Providence City Plan Commission

AGENDA ITEM 6 ■ 106 RESERVOIR AVE

**CASE NO./
PROJECT TYPE:** 22-064MI—106 Reservoir Ave
Minor Land Development

Proposed site plan

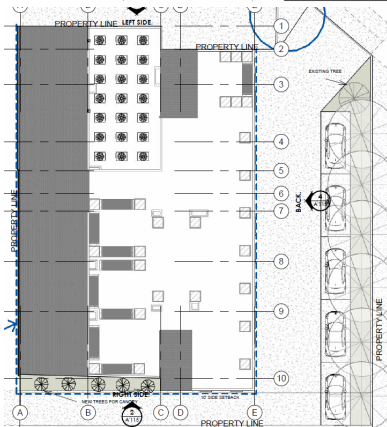
A total of 22 spaces are required for the development. Twenty one spaces are required for the residences calculated as one per unit, and one space is required for the 3,172 SF of commercial space where the first 2,500 SF is exempt from parking. Five spaces will be located parallel to the rear lot line and seven sheltered spaces will be provided under the building overhang. One of the spaces will be compact and the rest will meet the minimum dimensions of 8.5' x 18' with a 22' drive aisle. A dimensional adjustment for parking has been requested.

meet the 15% canopy coverage requirement. The plan indicates that plantings will be made in two landscaping strips, one adjacent to the parking area and the other to the south of the building. It appears that the applicant will meet the landscaping requirement using small trees around the parking area. The plan shall be subject to the City Forester's approval.

The applicant has included information on steps that will be taken to control sediment and erosion flowing off the site during construction as well as use of gutters and downspouts to direct stormwater to pervious areas. A utility plan shows that the building will tie in to the sewer from Reservoir Ave.

1. The landscaping plan shall be subject to the City Forester's approval.
2. The stormwater and erosion control measures shall be subject to the City Engineers approval.
3. Final plan approval should be delegated to DPD staff.
